FEDERAL COMMUNICATIONS COMMISSION
445 12th Street, S.W.
WASHINGTON DC 20554

In re: K235BU, Charleston Park, NV
BPFT-20090713AAJ
Facility ID No. 156220

This letter refers to the above-captioned application for K235BU, Charleston Park, Nevada.

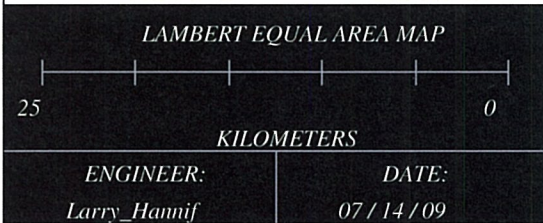
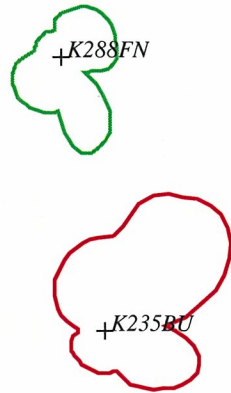
An engineering study reveals the application is a major change pursuant to Section 74.1233(a)(1) of the Commission's Rules. Specifically, the proposed 60 dBu service area fails to provide service to some portion of its 60 dBu licensed service area, (BLFT-20090706ABR). Therefore, the proposal is a major change. Because major change applications are not being accepted for filing, the application will be dismissed.

In light of the above, the application BPFT-20090713AAJ filed by Ondas De Vida Network, Inc. is unacceptable for filing pursuant to 47 C.F.R. § 73.3566(a) and IS HEREBY DISMISSED. This action is taken pursuant to 47 C.F.R. § 0.283.
